# **SERVICE BULLETIN**

## **Owner's Service Bulletin – OSB 31 Issue 1.0**

**Applicability – Ikarus C42A & B models with A-strut passing through main fuselage tube**

**Inspection of inside of A-strut for cracking**

**Figure 1; A-strut attachment to upper surface of main fuselage tube. Lower attachment bolt visible beneath main fuselage tube at aft end of bracket attached to nose leg.**

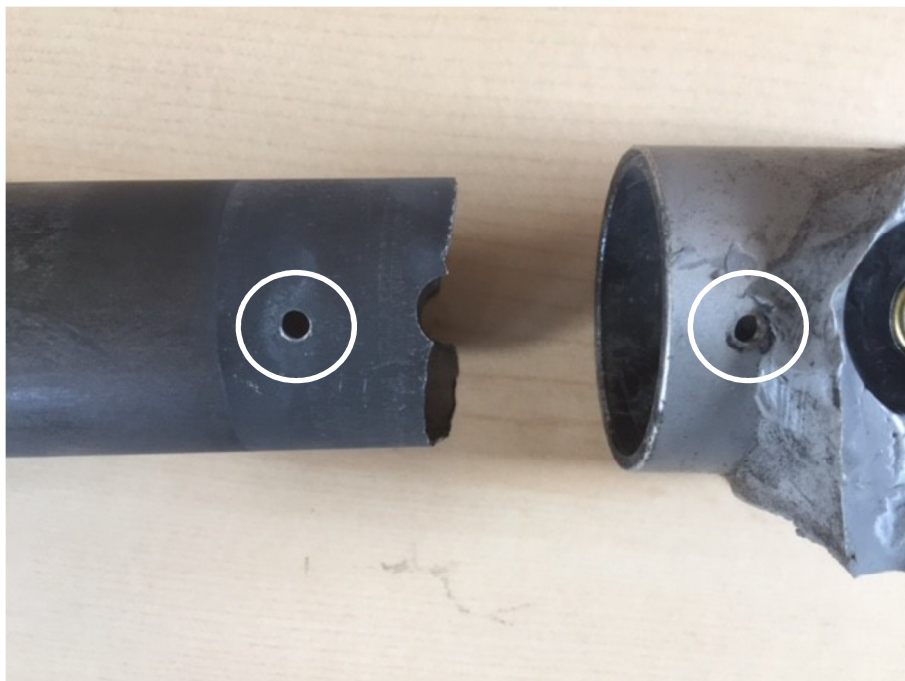
An aircraft with severe cracking of the main fuselage tube emanating from the upper cut-out for the A-strut was also found to have suffered severe cracking of the A-strut around its entire circumference. This was hidden within the outer sleeve positioned at the connection between the A-strut and the upper surface of the main fuselage tube. The load path was maintained by the single small rivet used to locate the outer sleeve on the A-strut. See Figures 1 & 2.

We recommend that before next flight the internal surface of the A-strut in the region of the bolt passing through it at the connection to the upper surface of the main fuselage tube is visually inspected for cracks, using a borescope inserted from the lower end.

We recommend that at the next annual or 100hr inspection, whichever comes first, the internal surface of the A-strut in the region of the bolt passing through it at the connection to the upper surface of the main fuselage tube is visually inspected for cracks, using a borescope inserted from the lower end.
